July 28th, 2022

Service Bulletin

SB22-001

EX40302E + HVG1P403MC

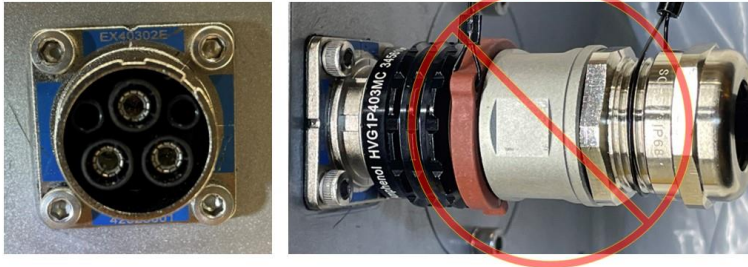
There is a potential for HVIL male terminals to make intermittent contact causing a break in HVIL circuit when using Amphenol HVG1P403MC on Accessories equipped with Amphenol EX40302~~6EM~~ receptacle.

Discontinue use of CSI P/N eHPS3.0CONT and eAC3.7CONT on accessories equipped with EX40302E High Voltage receptacle. Replace connector kit with updated CSI connector kit P/N eHPS3.0CONT-01 and eAC3.7HVCONT-01

EX40302E + EX40306EM

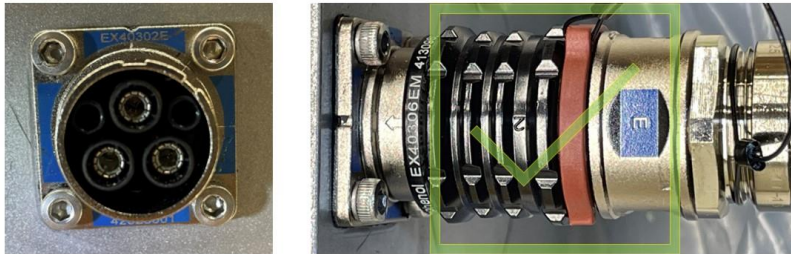
Affected Accessories received an update [to include IPXXB \(finger proof\) connectors.](#) The High Voltage receptacle was changed from Amphenol P/N HVG1S403FC to Amphenol P/N EX40302E. The [mating connector kit](#) was not updated [as they were supposed to be Forward/backward compatible, so, and](#) customers received Amphenol connector kit with Amphenol P/N HVG1P403MC. [The HVIL connections using HVG series connector/plugs and EX receptacles/sockets were found to have intermittent connections.](#) To ensure high quality HVIL connections, the [mating/Updated](#) connector kit will [include be replaced with](#) Amphenol P/N EX40306EM.
